AGENDA
La Vergne Planning Commission
April 30, 2024 at 6:00 PM

Item Title: Site Plan - UHAUL, Phase 2 - Two (2) Buildings Totaling Approximately 43,000 Square Feet on 10 Acres. Requested by SEC, Inc. Property located at 503 New Paul Road (Tax Map 17, Parcel 40.03). I-2 (Heavy Industrial) Zoning District. Property owned by Amerco Real Estate Co. **(WITHDRAWN)**

U-Haul Phase 2

Site Plan & Construction Drawings

DATE:	12-29-2023
CHECKED:	MAT, MPL
FILE NAME:	19084uhoul2.dwg
SCALE:	1"=30'
JOB NO.	19084
SHEET:	C2.2

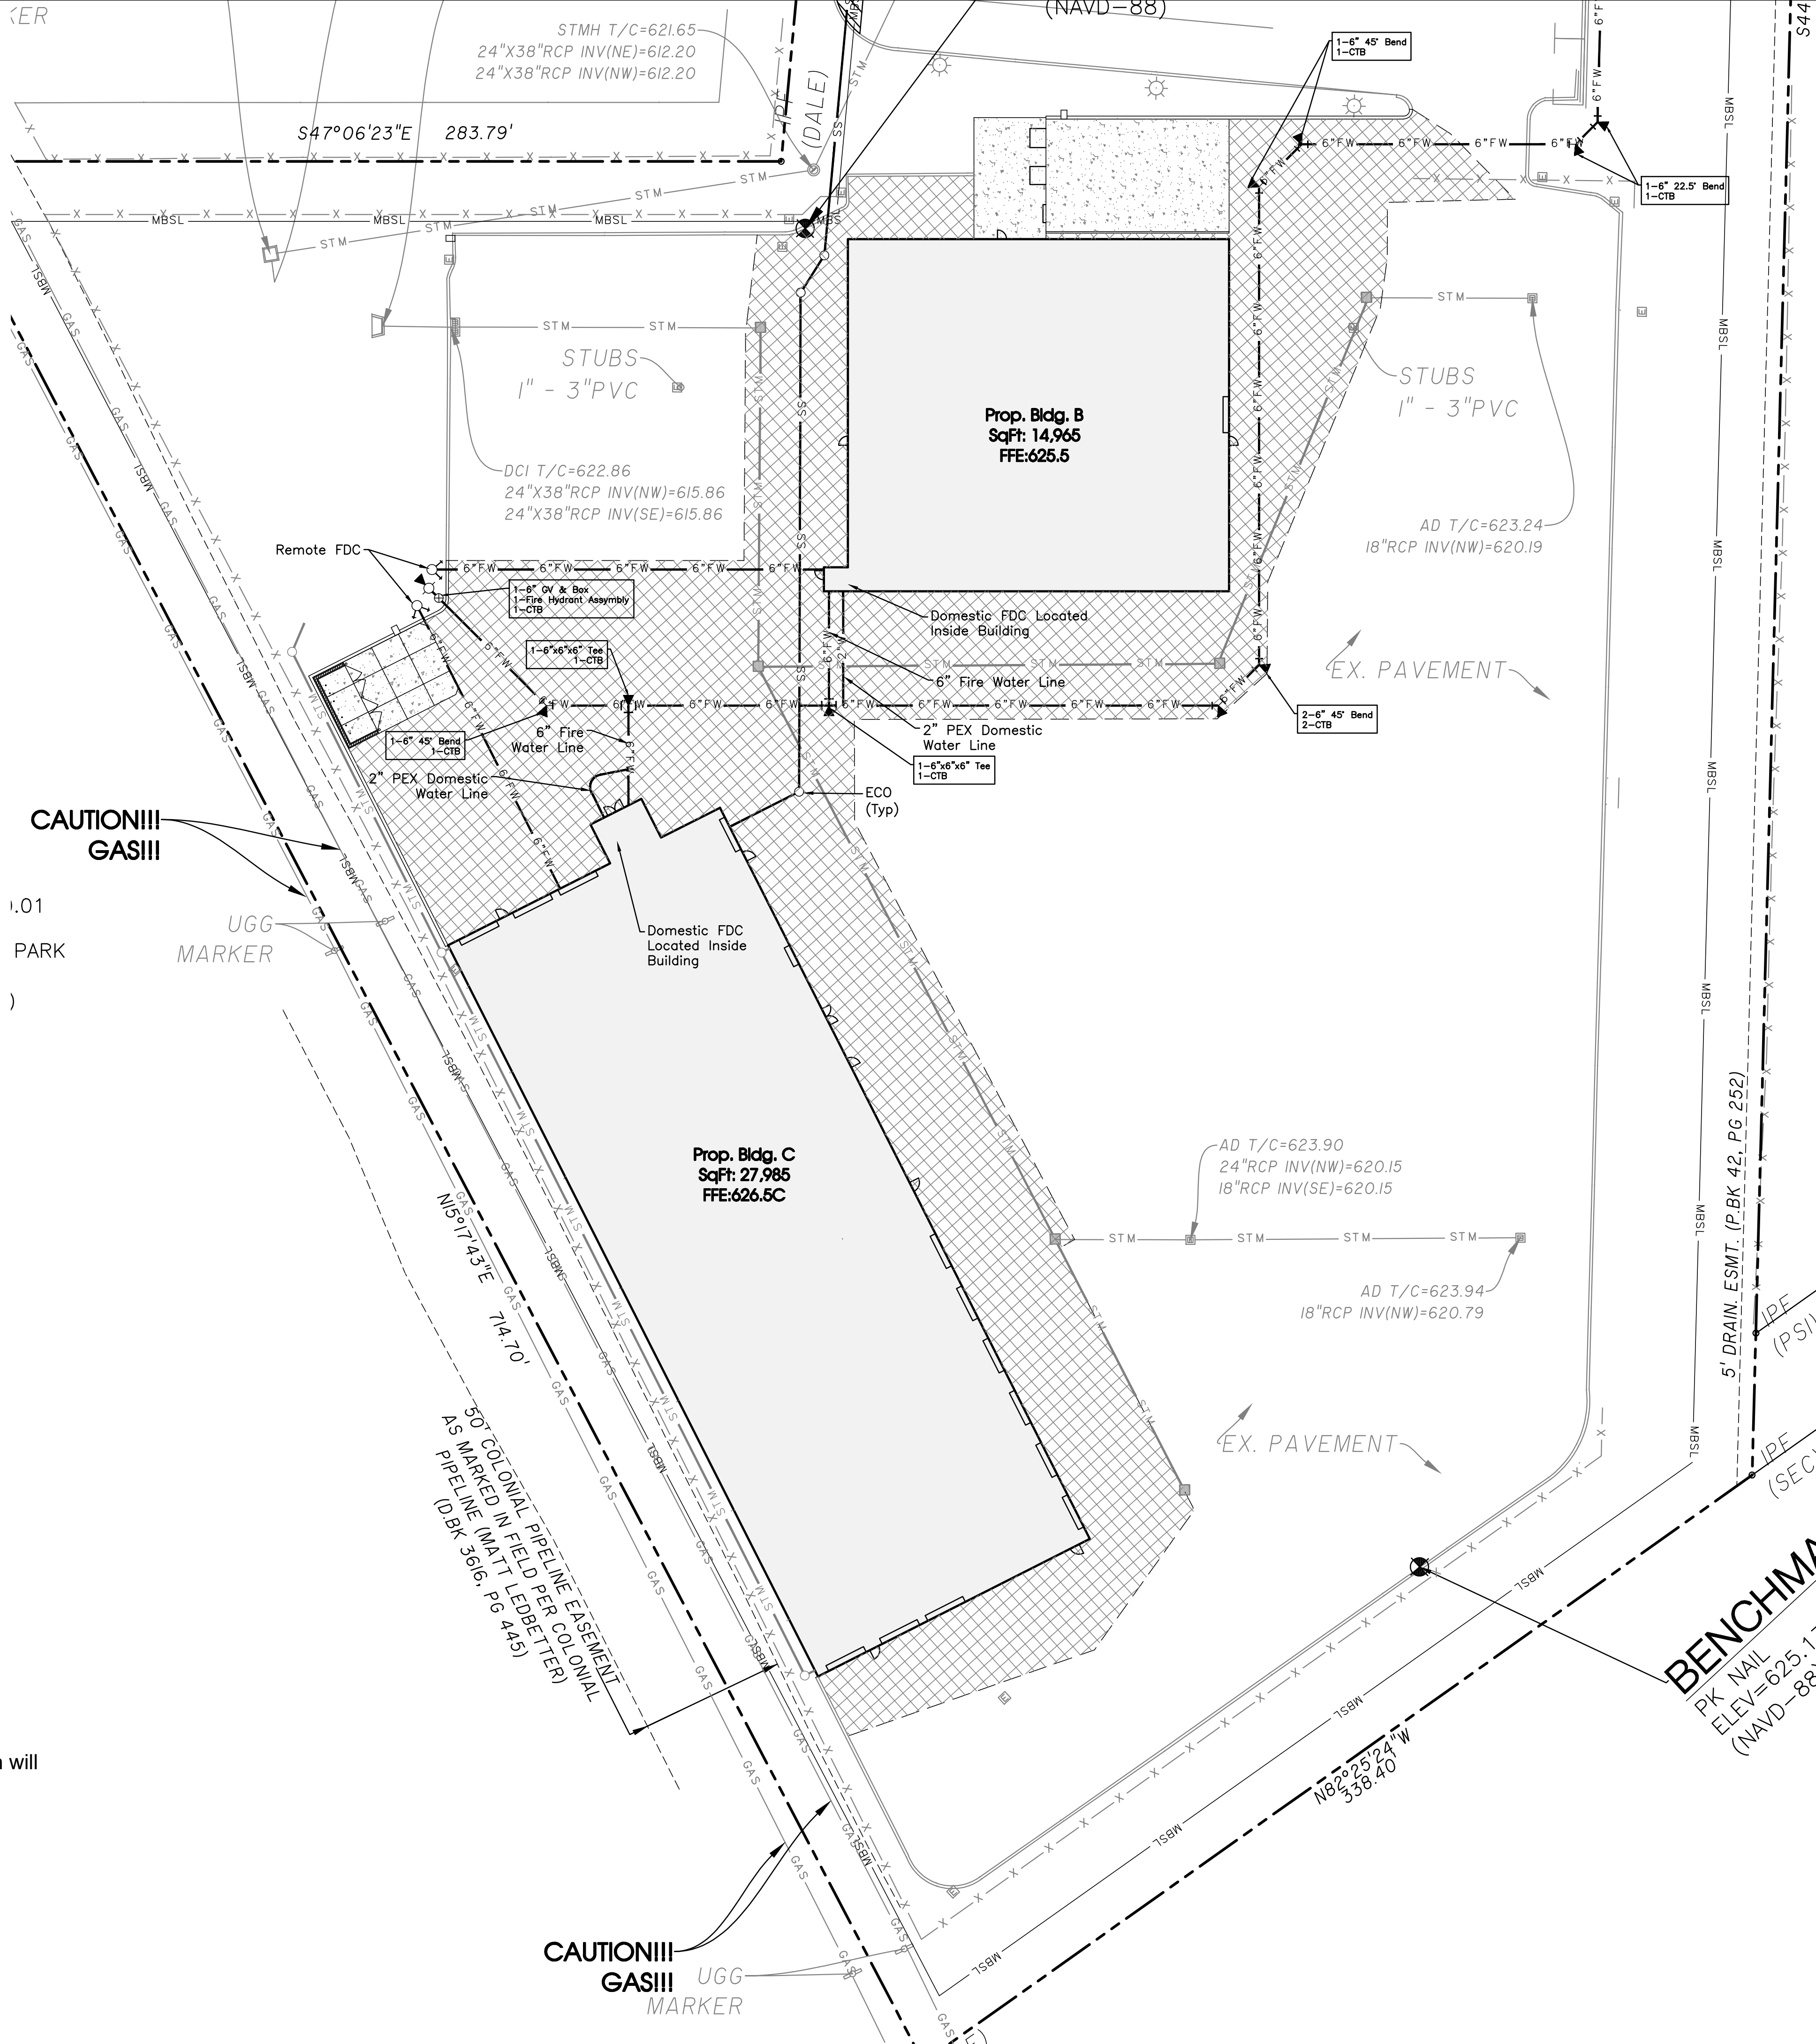
1. (For information) Sht C2.2: 2-way Fire Dept. Connection Detail – Per previous discussions with City Fire Marshall, the City wants a single 5" Storz connection. Detail provided graphically shows a Siamese connection. Please make this clear to avoid confusion.

3. (For Information) Sht C2.2: Fire Line Notes: Note 2 states "200 Pound Pressure Test." I believe the requirement was reduced to 150 psi test as part of NFPA 25, 2014, but please verify requirement with Fire Marshall, Curtis Brinkley.

4. (For information--to be provided for building permit) Sht C2.2: Please point to the location of the fire sprinkler riser inside each building and refer to a detail. Draw the detail. It should include but not be limited to the following:

C-4.0

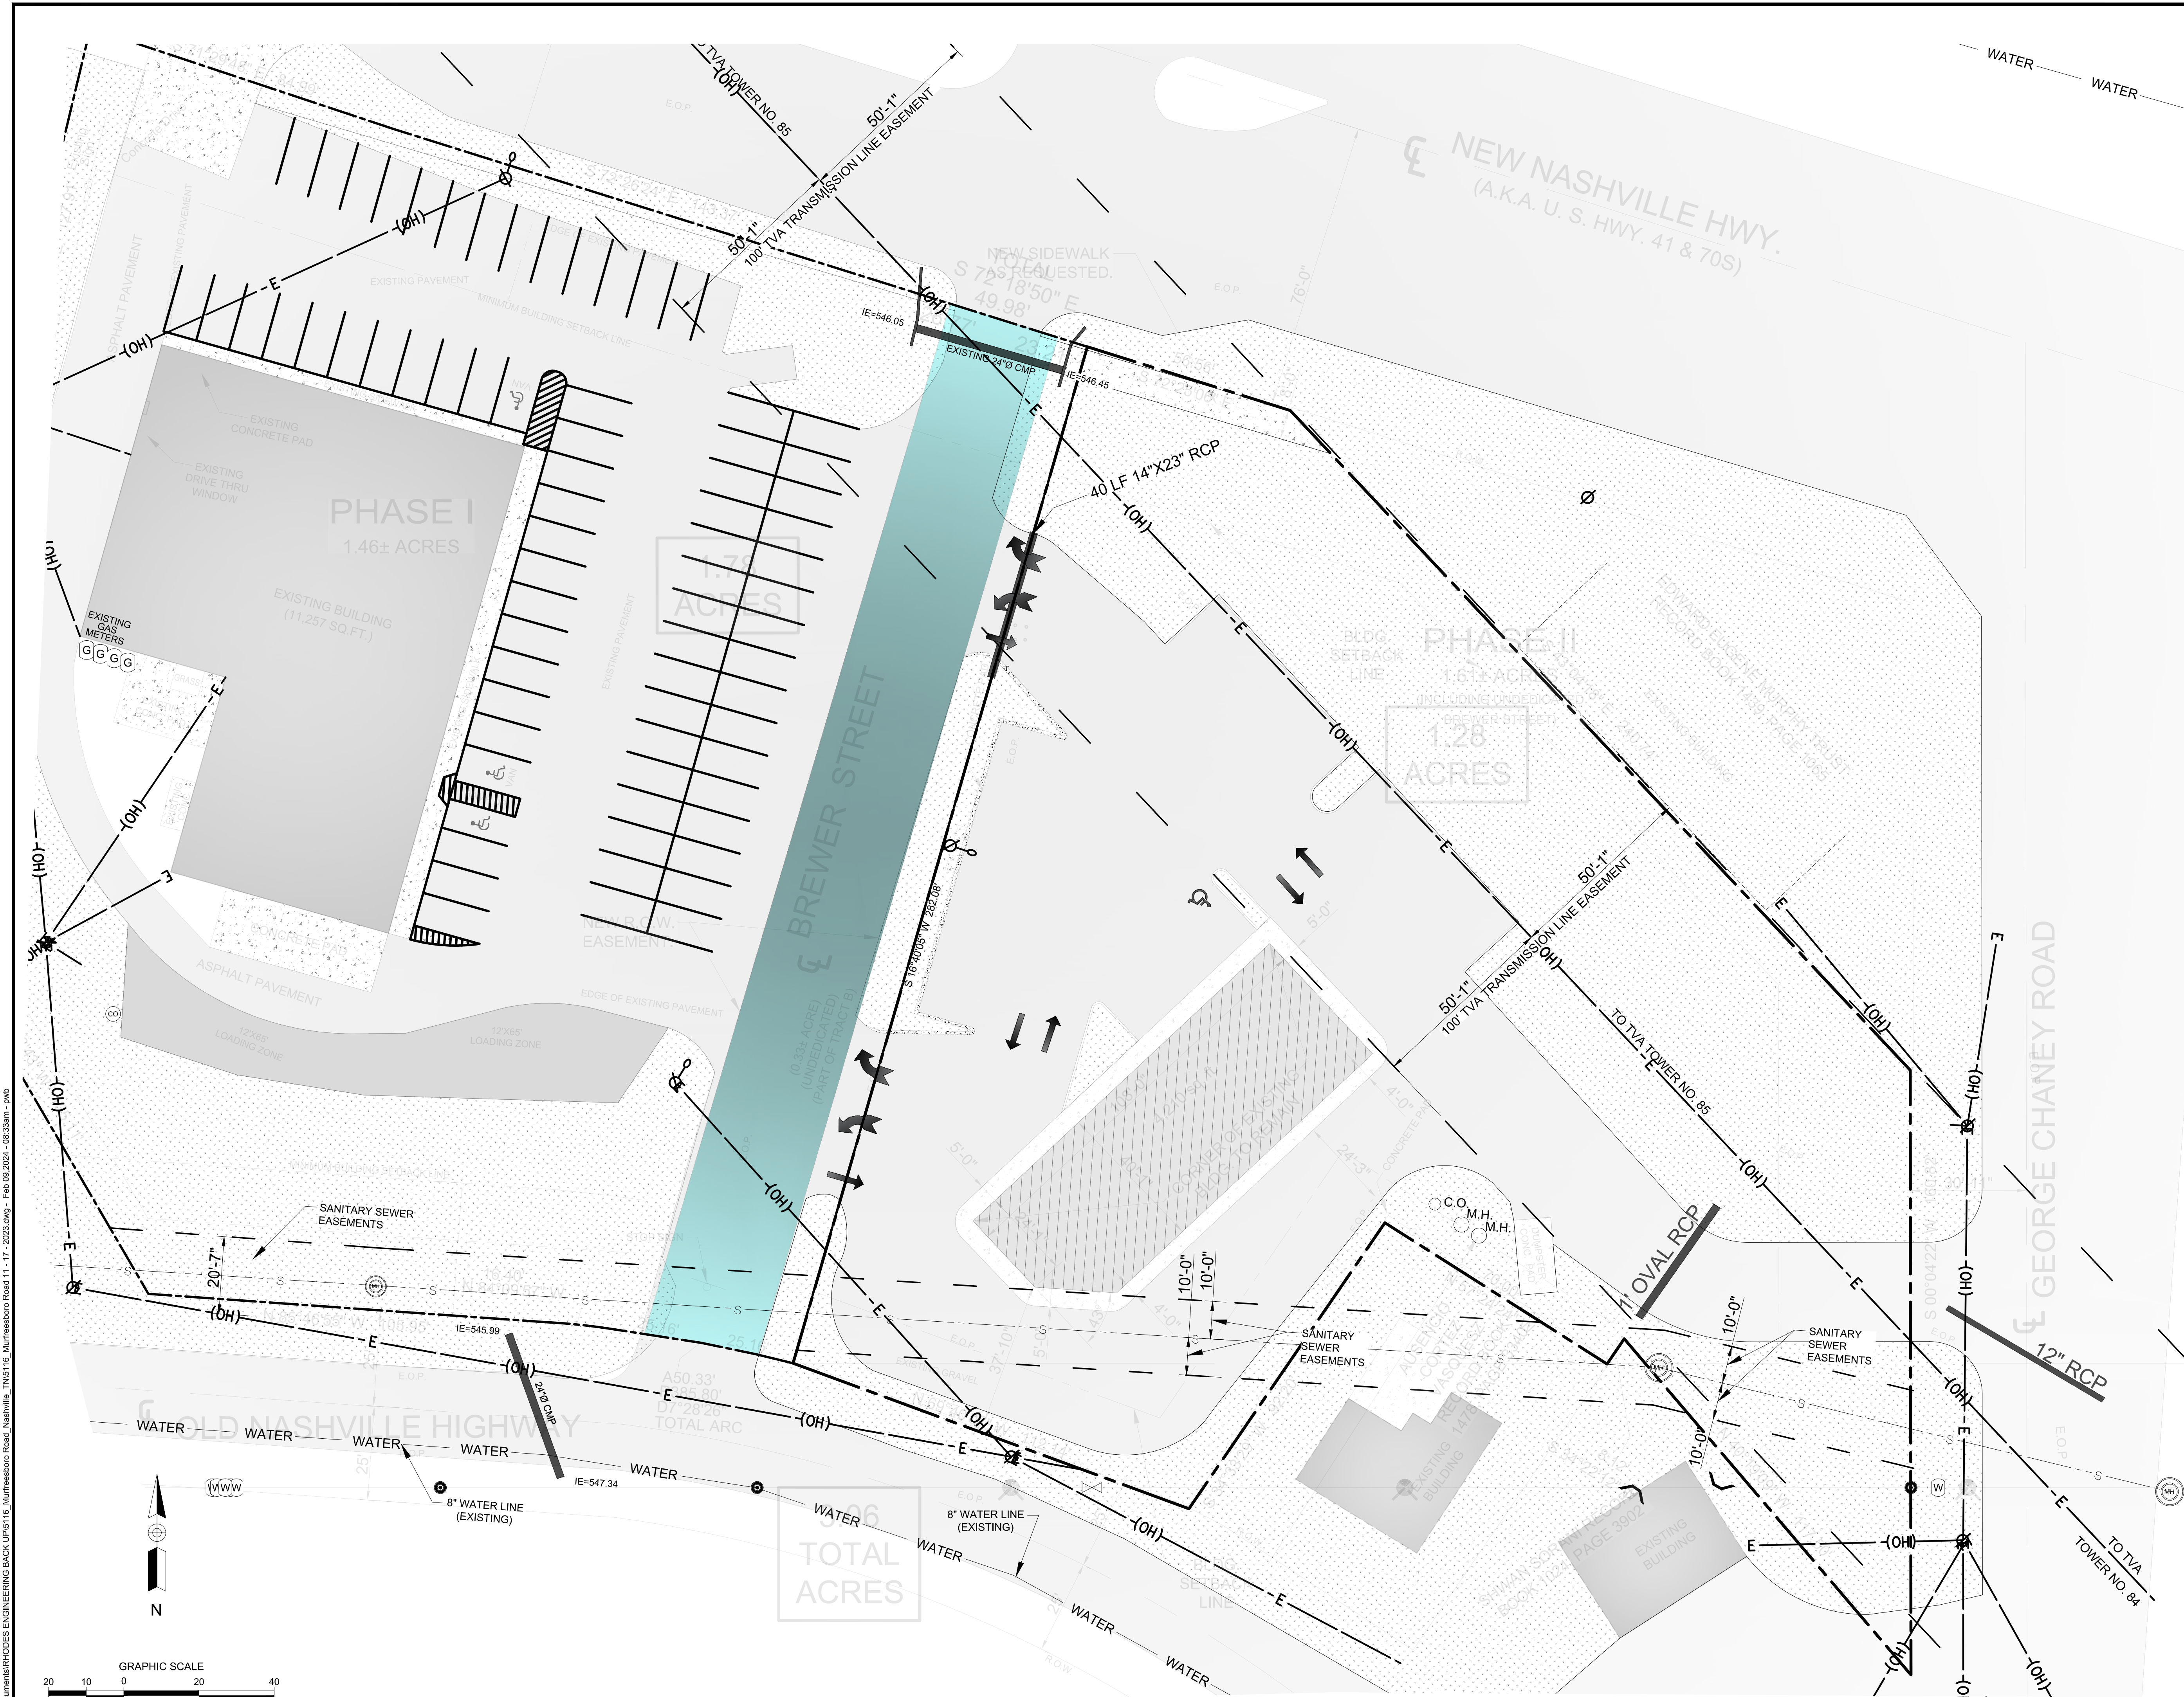
7. Provide erosion prevention and sediment control (EPSC) plans meeting the requirements of the Stormwater Management Ordinance. See Item 2 above.
8. (C-4.0) Show utilities serving proposed building even if they are existing. Engineer's response is that utilities are shown based on the survey which they were given. Staff considers the submittal incomplete.
